LMBHA001 - Electrical integrity Non-conformities at fabrication

QA.LMF 15/01/2020

11T Dipole Technical Meeting #22

NC1 : Defect insulation Aperture2 to the ground

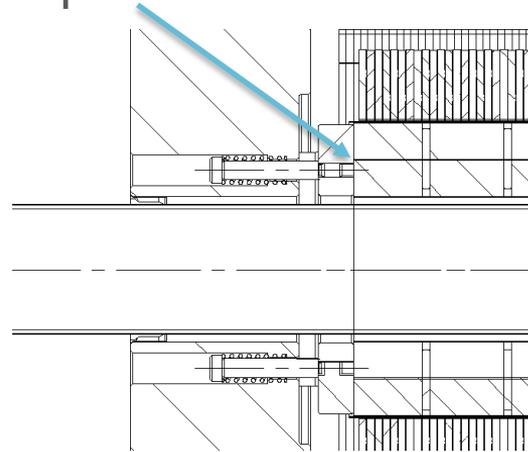
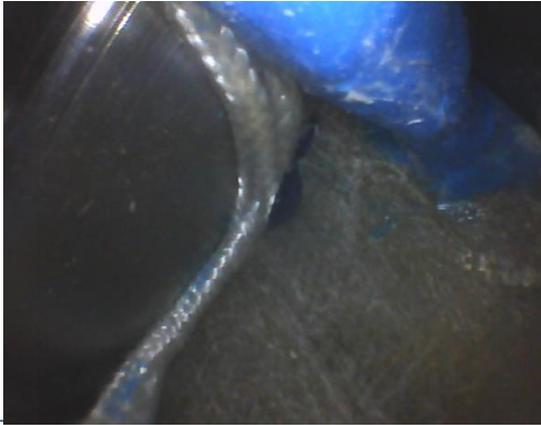
- Link: <https://edms.cern.ch/document/2226886>
- Defect detected @750V during HV tests.
- An endoscopy showed that 2 wires are damaged:
 - EE2161 is pinched between the plate and the coil's saddle

- EE2164 is pinched between the plate and the coil's saddle (wire cut)

- Disposition:
 - EE2164: the wire is not replaced
 - The extremity was insulated with a polyimide tube ($\varnothing 3$) filled with Eccobond.

- A 2nd polyimide tube ($\varnothing 5$) is applied over the first.

NC1 : Defect insulation Aperture2 to the ground

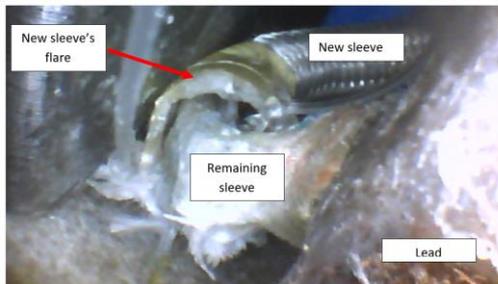
- EE2161:

- The damaged glass fibre sleeve is removed and trimmed.

- A new sleeve is slid on, then glued with Eccobond

- The repairs were validated with a HV test at 3.3kV during 2min.

NC3 : Electrical defects during Cold Tests

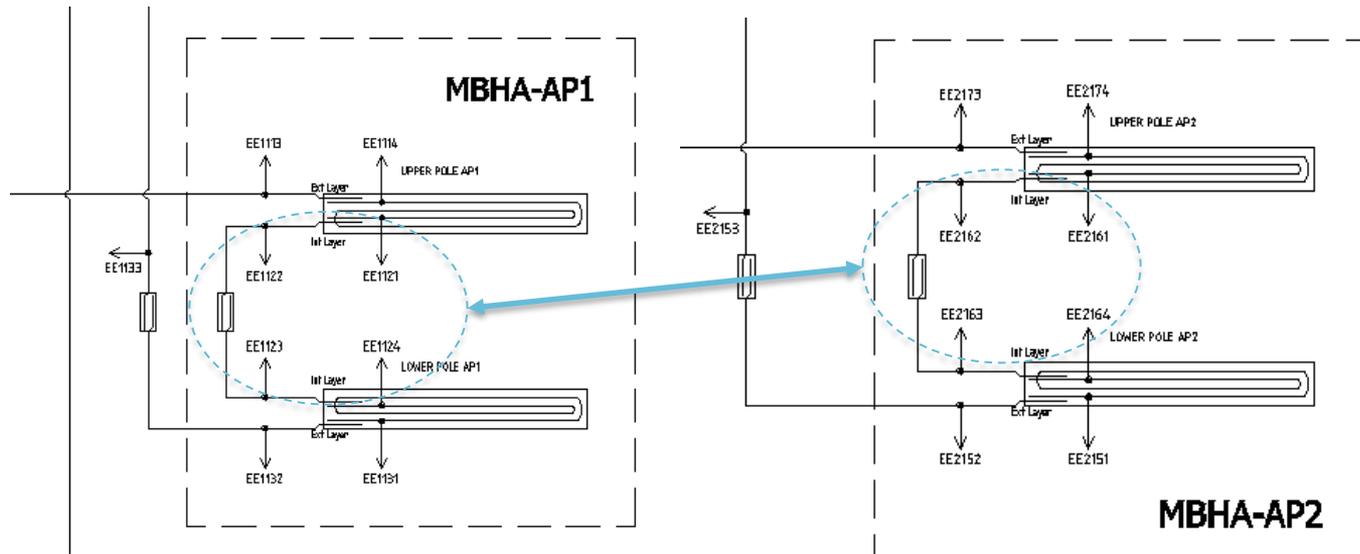
- Defect 2: In quench 2 and 3 unusual spikes were seen on the voltage signals.
 - Further investigations (EDMS 2281449): It seems most likely that wire 1121, 1122, 1123 or 1124 is touching one wire 2161, 2162 or 2163 somewhere in the bundle of wires, possibly in the capillary (EDMS 2281449).

NC3 : Electrical defects during Cold Tests

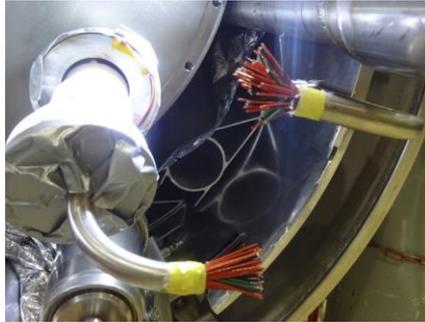
- Investigation:
 - The capillary tube is being dismantled:

- Several electrical tests were performed meanwhile under different conditions (Voltage, injection of He...). Those tests didn't reveal any defects.
- Several visual inspections were carried out:
 - Endoscopy in the flat cover,
 - Visual inspection of the wires near the cold head,
 - Visual inspection of the wires in the warm head (after cutting the cover flanges).

NC3 : Electrical defects during Cold Tests

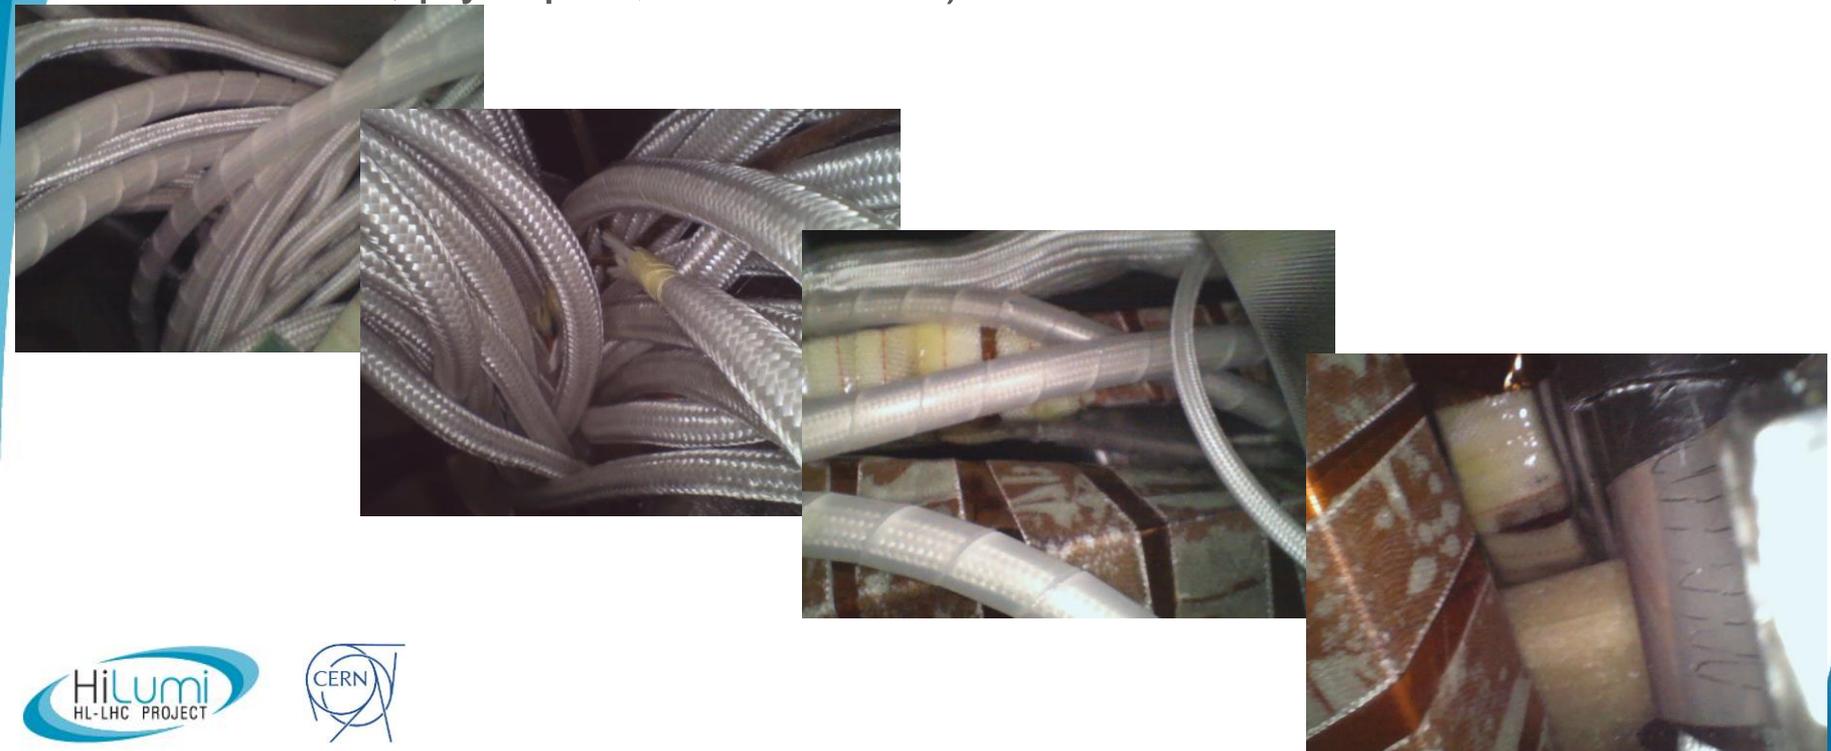
- Visual inspection:
 - Endoscopy didn't show any damage (fibreglass, heat-shrink sleeves, plyospire, insulation...).

NC3 : Electrical defects during Cold Tests

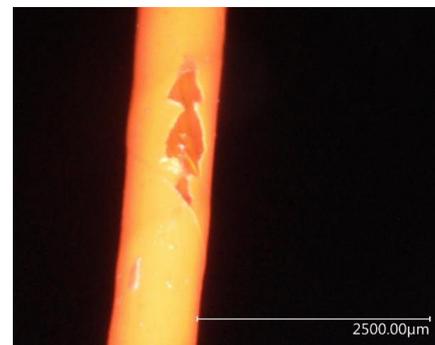
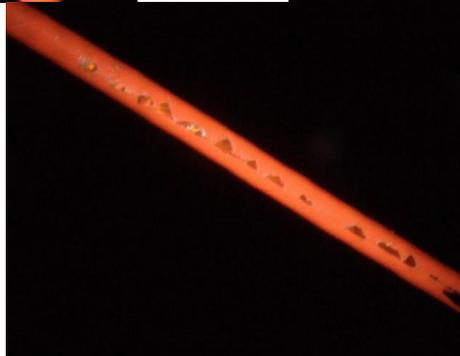
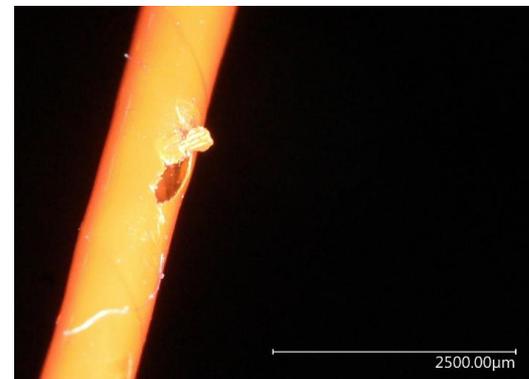
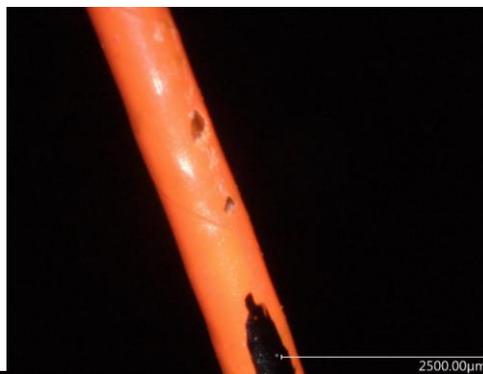
- Visual inspection of the wires near the cold head
 - Different types of defect were found:
 - External sleeve scratched (18 defects)

NC3 : Electrical defects during Cold Tests

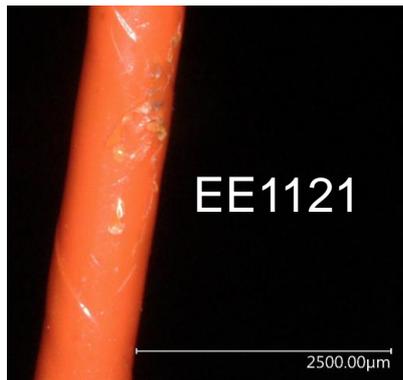
- Conductor visible (1 defect, EE1123):

- Black stain (3 defects, EE1121, EE043 and EE042):

NC3 : Electrical defects during Cold Tests

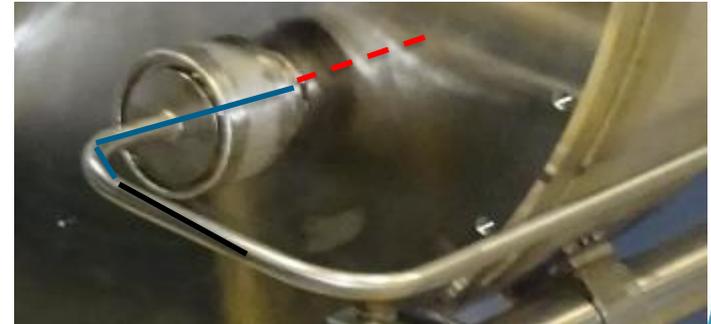
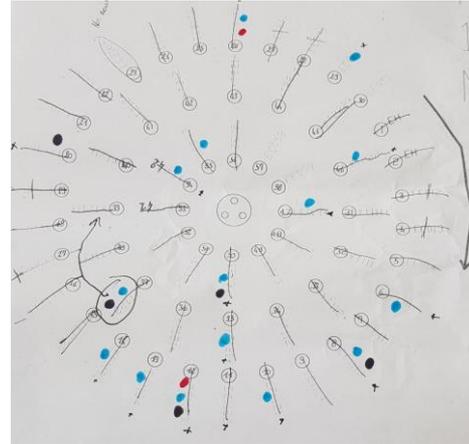
- Positions of the defects:
 - This sketch shows the arrangement of the wires in the capillary.
 - Most of the defects seem to be positioned in and before the first turn of the capillary (in blue).
 - Defects showed by black spots are at the extremity of the wires (likely caused during the IFS cutting),
- Defects showed by red spots are in under the flat cover.

Positions of the defects (for all NCR)

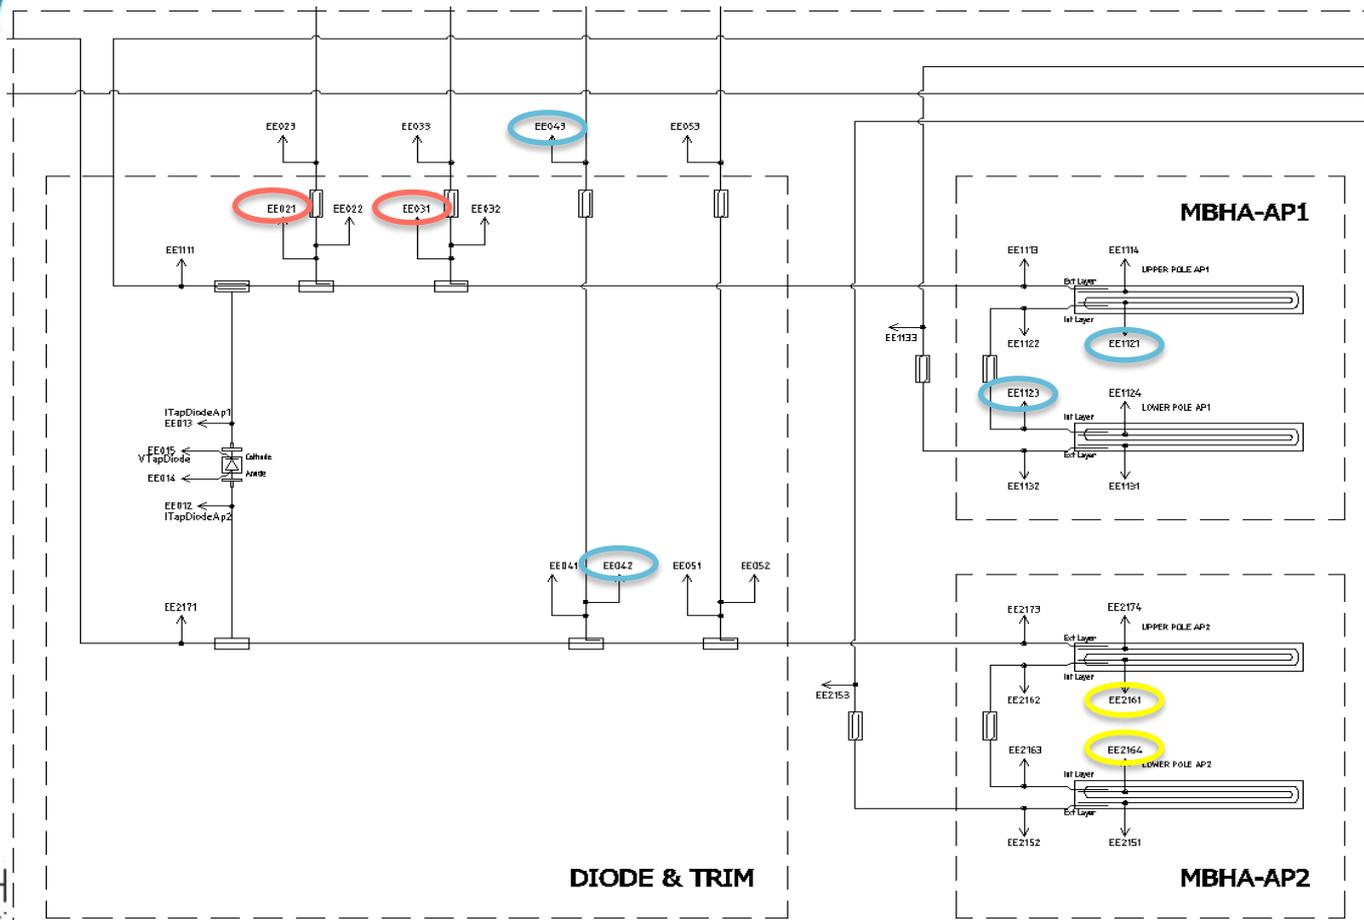
- Visual inspection of the wires near the warm head:
 - Different types of defect are found:
 - External sleeve scratched (13 defects),
 - Conductor visible (1 defect, EE021),
 - Black stain (1 defect, EE031).
 - These defects are close to the warm end (possible direct contact?)

-  Defects near bullets (NC1)
-  Defects near cold head (first turn, NC3)
-  Defects near warm head (NC3)

Corrective actions

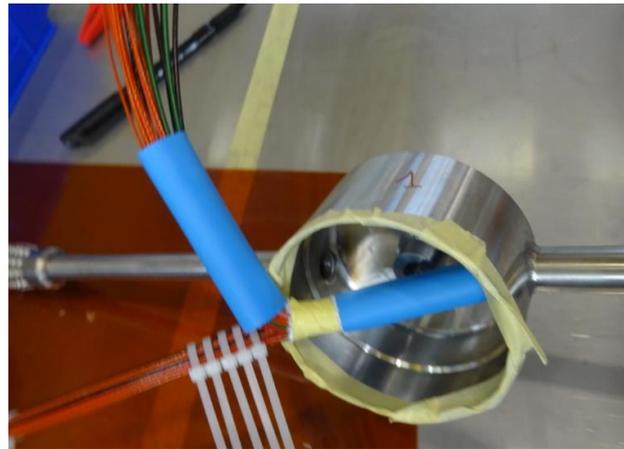
- NCR3:
 - All the defects, which have been observed, are on the wires touching the edge of the warm head.

- Therefore, extra insulation could avoid scratches caused by friction at this location (picture taken on the new IFS).
